Subject: RE: DA 2022 1848; 173A Seaforth Crescent Seaforth NSW 2092 WRITTEN
SUBMISSION: LETTER OF OBJECTION SUBMISSION: NG

RE: DA 2022 1848; 173A Seaforth Crescent Seaforth NSW 2092

WRITTEN SUBMISSION: LETTER OF OBJECTION
SUBMISSION: NG

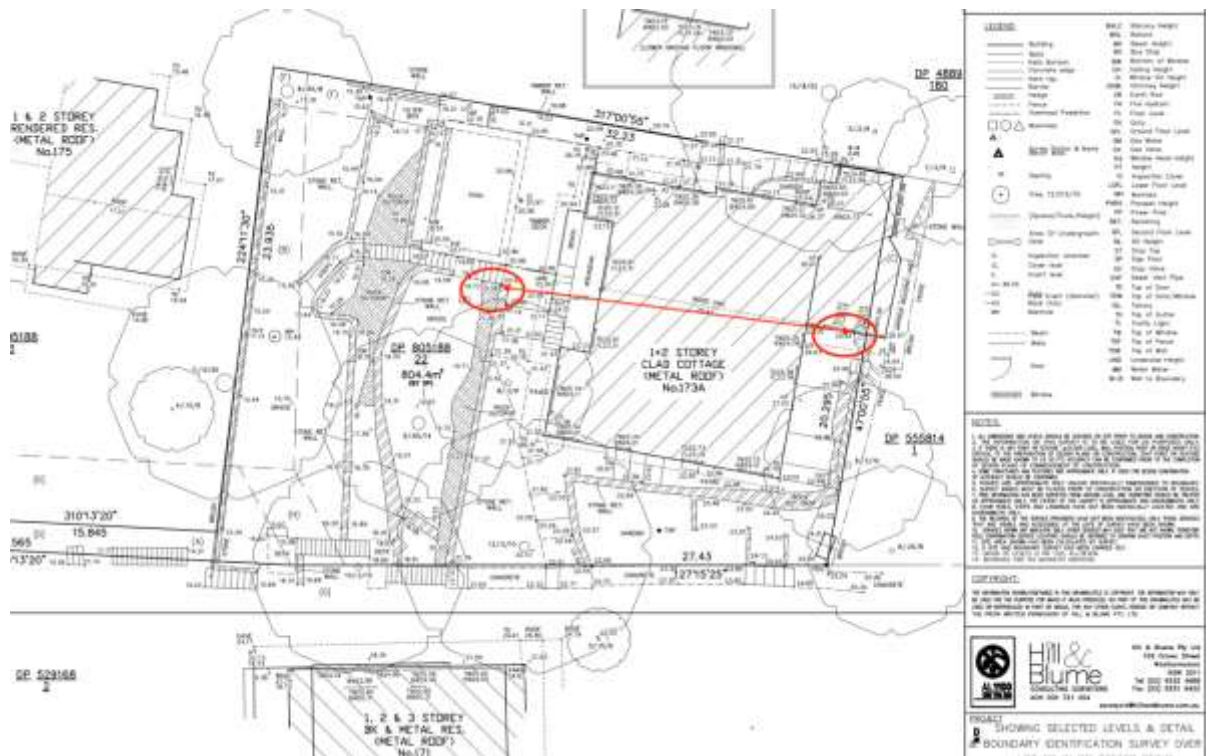
We contend that *ground level (existing)* on the subject site has not been assessed correctly.

We contend that the Applicant has avoided locating the Registered Surveyors spot levels onto the plans, sections and elevations to falsely suggest that the heights are lower than what is truly correct.

Council will note that there are no '*ground level (existing)*' survey marks on the Applicant 's Survey under the existing dwelling.

Council will also note that the Applicant is using tops of retaining walls and artificially raised decks as '*ground level (existing)*'.

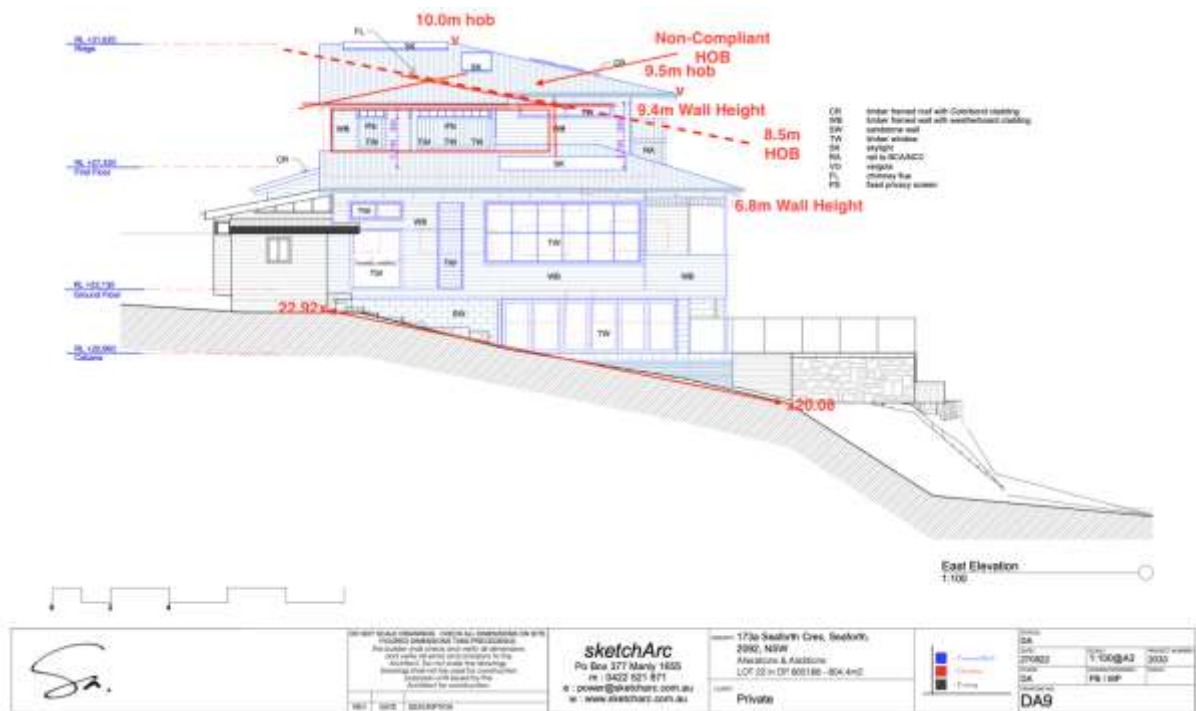
Council will note that when these levels of 20.08 and 22.92 are positioned on the East Elevation, this clearly shows that the extrapolation between these spot levels, equates fairly accurately to the *ground level (existing)* shown on the East Elevation.

Council can easily then identify that the proposed development is substantially above the 8.5m Height of Building standard to a height of 10.0m, and the Wall Height control to a height to 9.4m.

Council will note that a compliant envelope to the true 8.5m Height of Building standard, would require the upper level to be substantially redesigned. We indicate on the above sketch the reductions that would be required including a substantially reduced hip roof with a low pitch profile to minimise view loss of the harbour. We address this matter latter in the Submission.
